Sub Regional RTEP Committee PJM West

April 20, 2020

Project Update

Additional Scope for Project B3087

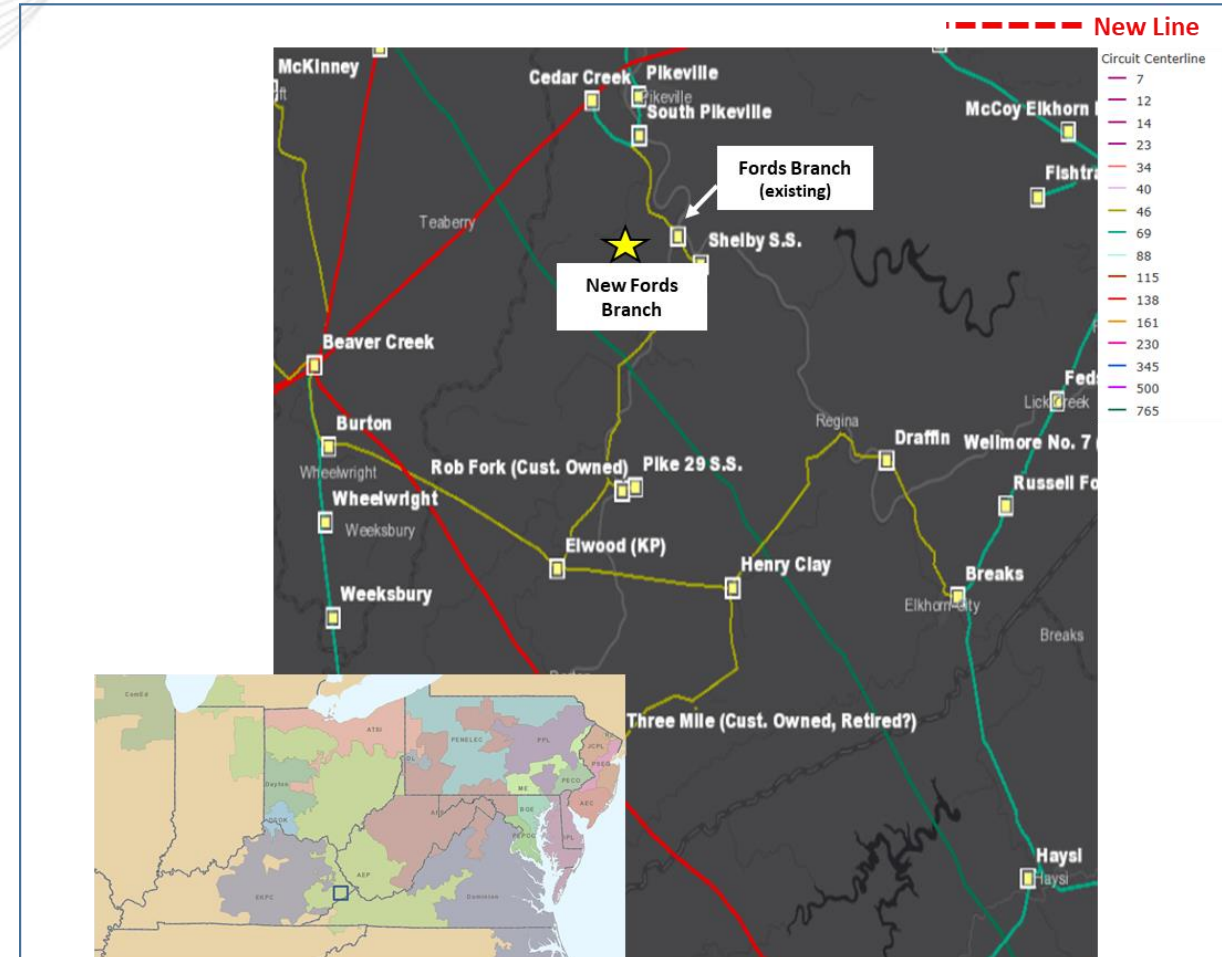
Additional Scope: Install a 28.8MVar switching shunt at the new Fords Branch substation **(B3087.4)**

Reason for the additional scope:

- For the N-1-1 Loss of Beaver Creek Transformer #1 and the loss of Cedar Creek – Johns Creek 138kV line, voltage magnitude violations are identified at New Fords Branch substation (0.90 pu), Cedar Creek 138kV (0.90 pu).
- For the N-1-1 Loss of Beaver Creek – Kewanee (New Fords Branch) 138kV and Cedar Creek – Johns Creek 138kV line, voltage magnitude violations issues are identified at the new Fords Branch substation (0.87 pu), Cedar Creek 138kV (0.87pu), Cedar Creek 69kV (0.90 pu).
